SVE BULLETIN

QVM Bulletin: Q-253 Date: 09 August, 2016

2017 MY F-Series Super Duty 6.7L Exhaust System Modifications

Models Affected: 2017 MY to present F-Series Super Duty Pickup (F-250/350/450) and Chassis Cab with

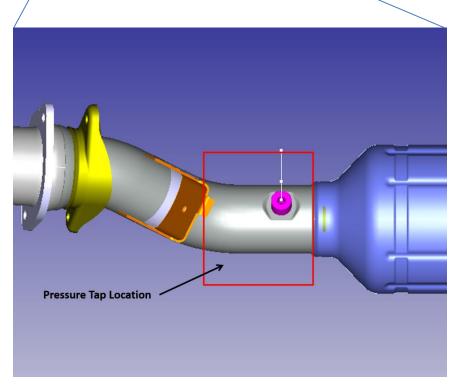
<u>Description:</u> Modifications to the exhaust system, when required to accommodate service body

RED: Areas that CANNOT be modified due to durability or functional requirements.

YELLOW: Areas that are NOT RECOMMENDED for modification due to critical clearances to rear axle motion envelope.

GREEN: Areas that are allowed to be modified.

PT A - PT B: Any modifications between Pts A - B must not shorten the centerline length between the two points to a length less than that of the shortest wheelbase. MIN Centerline Length = 1160 mm for reference.

PT B – PT C: Any modifications between Pts B – C must not shorten the centerline length between the two points and should be made using pipe diameter equivalent to the OEM assembly. MIN Centerline Length = 400 mm for reference.

- Dual tip diffuser cannot be removed or altered.
- Modifications must not change system restriction or alter the performance of the dual tip diffuser (see following performance assessment recommendations).
- Appropriate heat shielding must be utilized if required.
